Great Western Highway East – Katoomba to Blackheath

Submissions report

Transport for NSW | October 2022

FIGURE 3-1a: Drainage catchments - Katoomba to Medlow Bath section

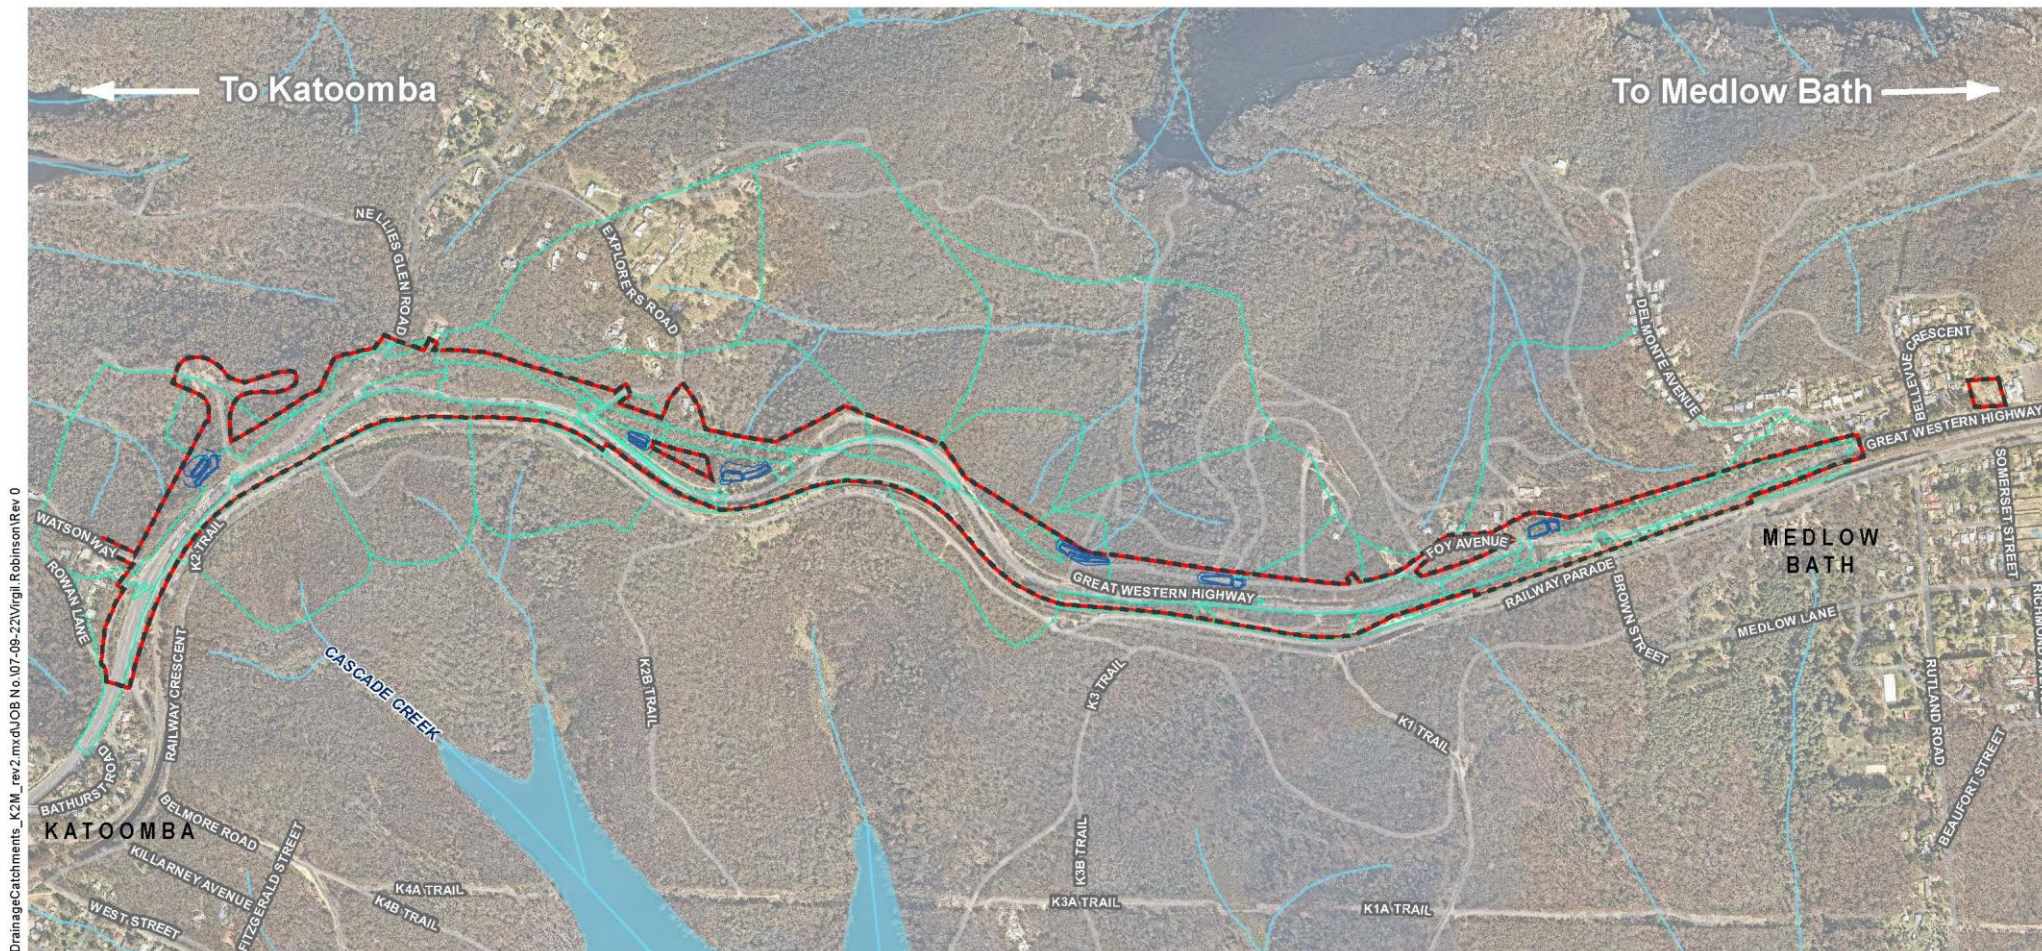
The catchments assessed as part of the proposal are shown in

Figure 3-1a-b. The western extension of the active transport trail outside the REF proposal area has been included in the operational MUSIC modelling carried out for the revised design (refer to Section 5.1).

Great Western Highway East **Submissions Report**
FIGURE 4-1a: Revised design - Katoomba to Medlow Bath section

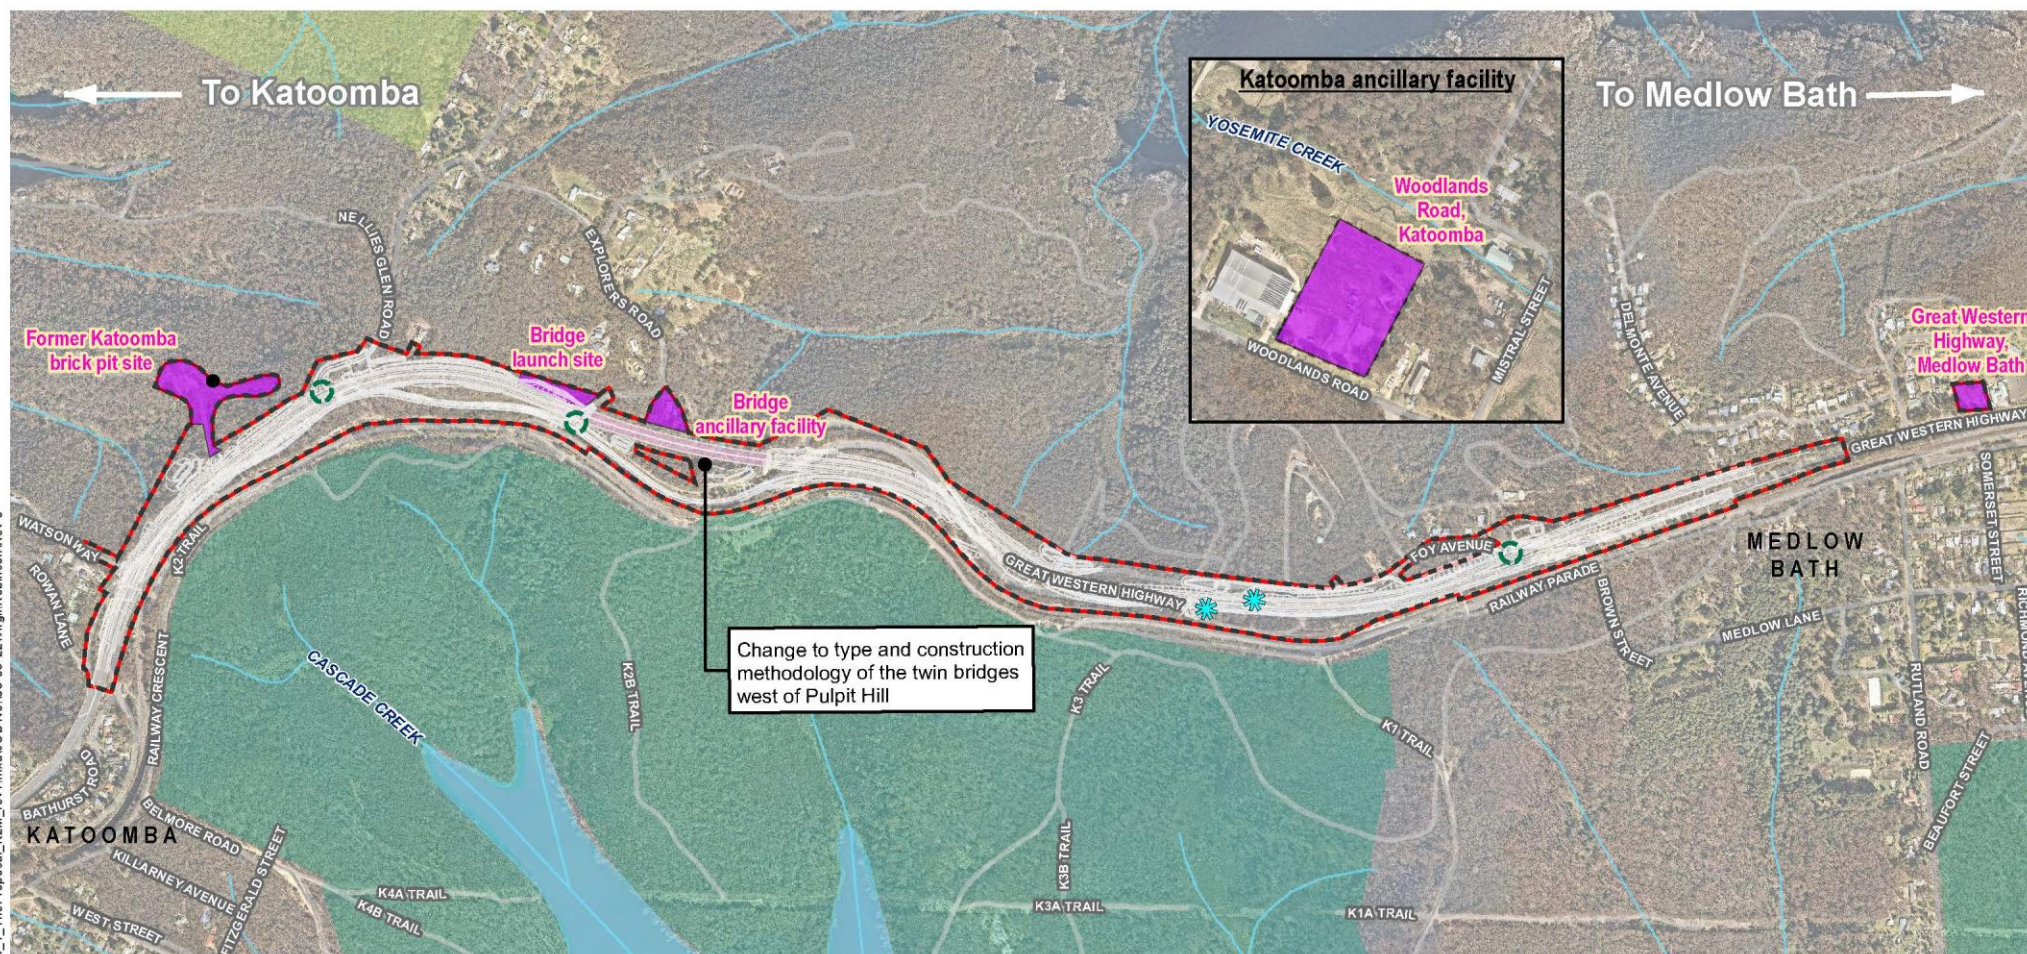
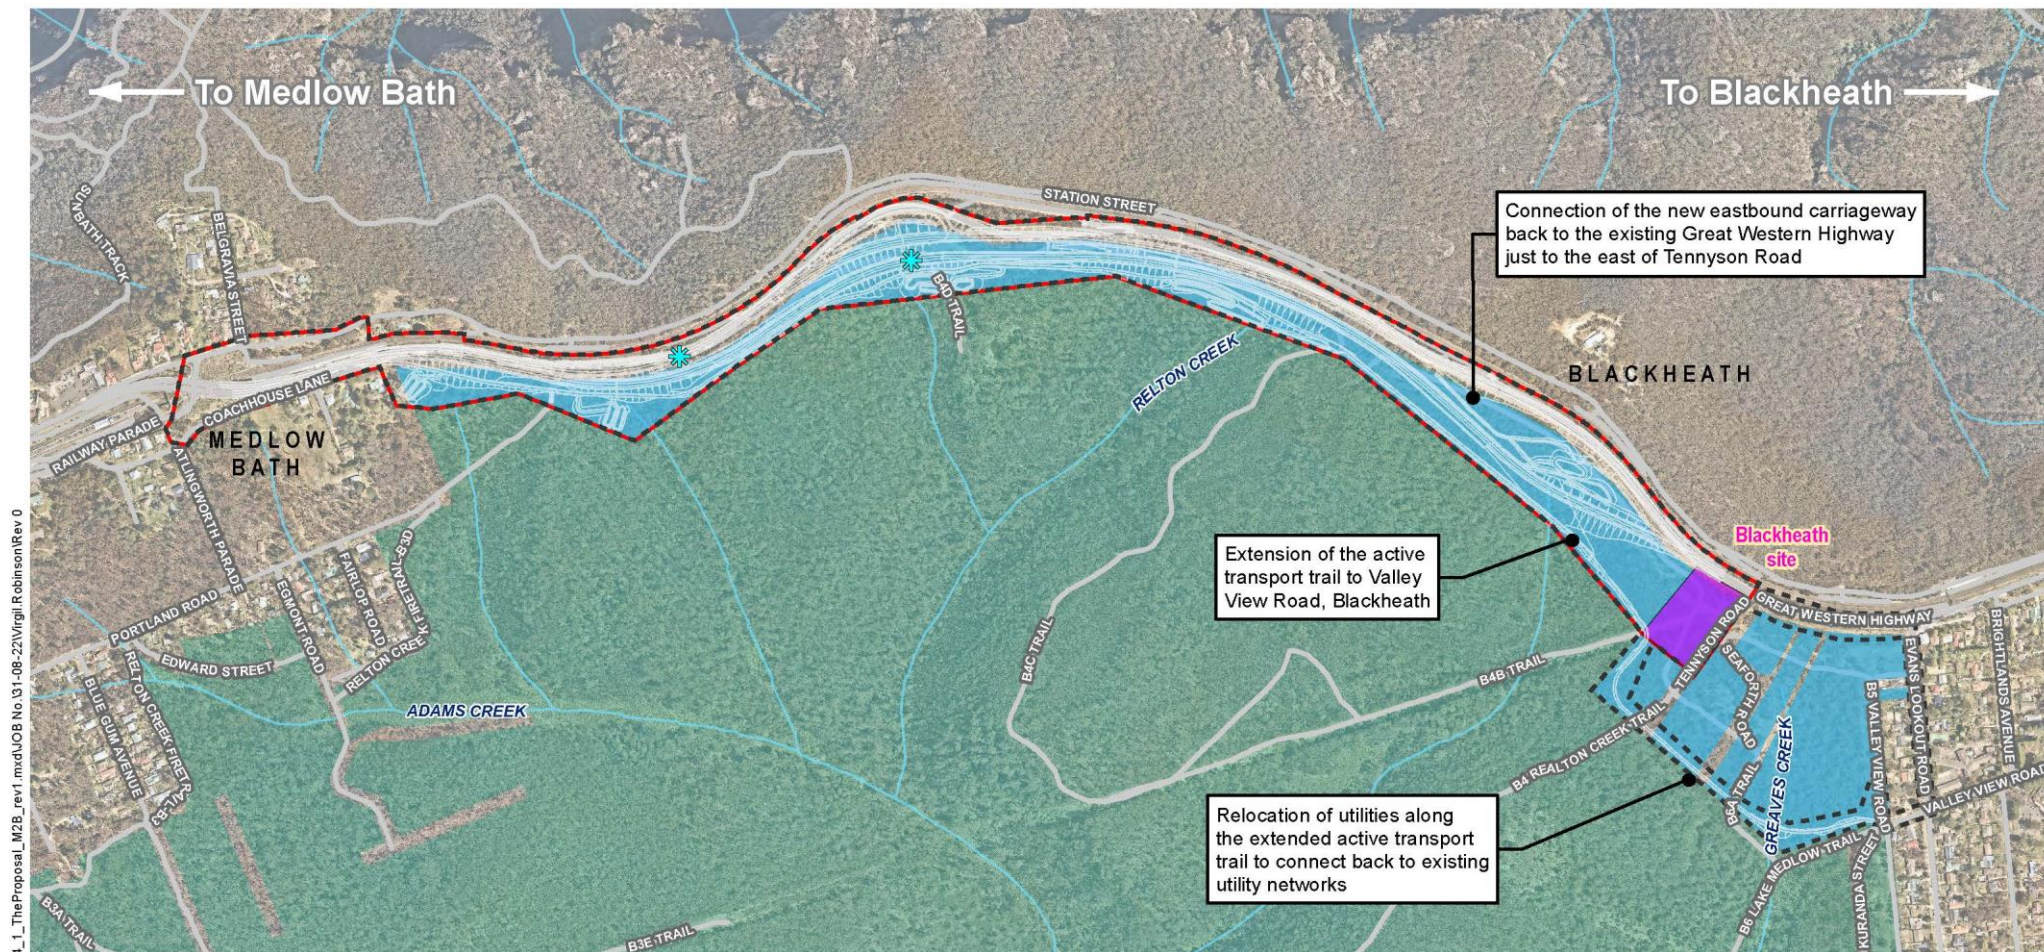
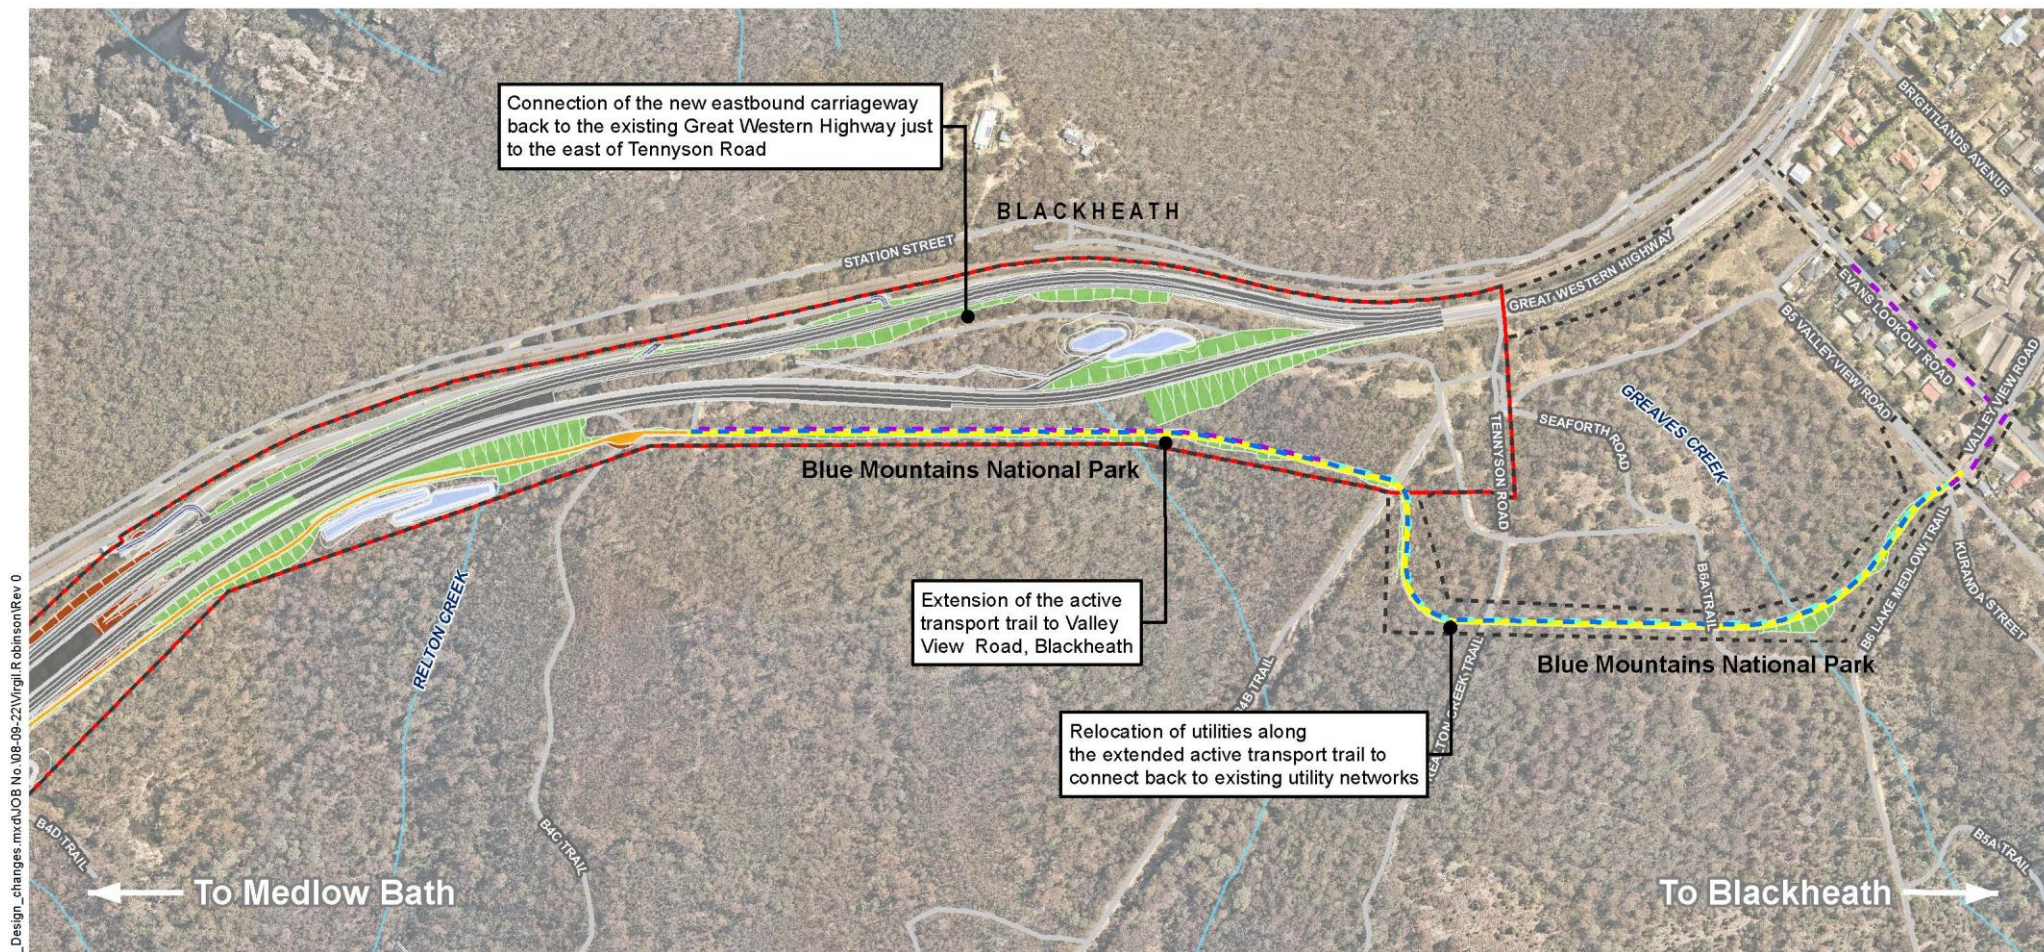
Figure 4-1a-b outlines the revised design and Figure 4-2 indicates the locations where design changes are proposed in the revised design compared to the design outlined in the REF. These figures identify the revised proposal area, which includes a western extension of the REF proposal area towards Blackheath and has been developed as the footprint required for the construction of the revised design.

- Minor adjustments to maintenance access and rail corridor interfaces in both sections of the proposal.
- Type and construction methodology of the twin bridges west of Pulpit Hill to introduce bridge designs that minimise environmental impacts.

- Optimising the lane alignment tie-in near Coachhouse Lane.
- Sealing of unsealed sections of active transport trail.
